Access Compliance Report

Public Rights-of-Way

(Curb Ramps)

Intersection ID: 13108	Main Street: E MARTIN LUTHER KING JR BV	Cross Street: S DAVIDSON ST	Location: S
ADA ID: 80EFCF056A29	Ramp Type: PerpDiag	Initial Pass/Fail: Pass	Overall Compliance: No
Severity Score: 10.25			
Codes/Mitigation Info/Possible Solution		Field Measurements/Component Compliance

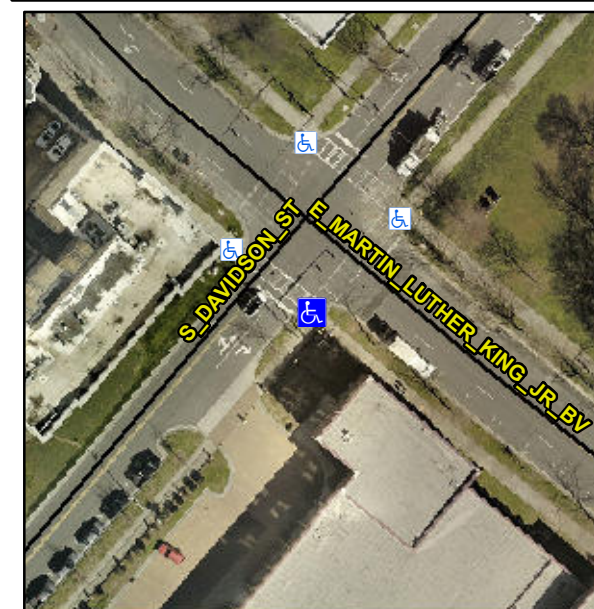
Not Found, R304.5.3, R304.2.1, R304.2.2-Perp, R304.3.2-Para

Compliance	Description	Data	Compliance	Description	Data
N/A	Ramp Length (in)	89.0	Yes	Ramp Slope (%)	7.2
Yes	Ramp Width (in)	48.0	No	Ramp XSlope (%)	4.1
N/A	Flare Type LT	Sloped	N/A	Flare Type RT	N/A
N/A	Flare Slope LT (%)	5.6	Yes	Flare Slope RT (%)	3.4
N/A	Flare Traversable LT?	No	N/A	Flare Traversable RT?	Yes
No	Landing Length (in)	N/A	Yes	DWS Provided?	Yes
No	Landing Width (in)	N/A	Yes	DWS Contrast?	Yes
No	Landing Slope (%)	N/A	Yes	DWS Length (in)	24.0
No	Landing X Slope (%)	N/A	Yes	DWS Full Width?	Yes
N/A	Landing Curb? (Y/N)	No	Yes	DWS Offset (in)	2.0
N/A	Shared Landing?	Yes			
Yes	Gutter Ponding?	No	Yes	Gutter Slope (%)	1.2
Yes	Gutter Lip Ht (in)	0.0	Yes	Gutter X Slope (%)	1.6
N/A	Painted X Walk1?	Yes	N/A	Painted X Walk2?	Yes
	X Walk 1 Direction	To NE		X Walk 2 Direction	To NW
N/A	X Walk 1 Width (in)	112.0	N/A	X Walk 2 Width (in)	90.0
	X Walk 1 Slope (%)	1.5		X Walk 2 Slope (%)	0.8
	X Walk 1 X Slope (%)	0.8		X Walk 2 X Slope (%)	2.2

Yes	Ramp inside XWalk1?	Yes	Yes	Ramp inside XWalk2?	Yes
	Road Slope (%)	1.3	N/A	Clear Space?	Yes
	Road X Slope (%)	0.8	No	Clear Space to XWalk (in)	20.0
Yes	Any Obstructions?	No	Yes	Storm Grate/Utility Hazard?	No
	Obstruction Type			Storm Grate/Utility Type	
		N/A			N/A
			Yes	Surface Condition? (G/P)	Good

Remove & Replace Curb Ramp With Two New Directional Ramps or Equivalent. Restripe Crosswalk(s) To Provide Clear space.
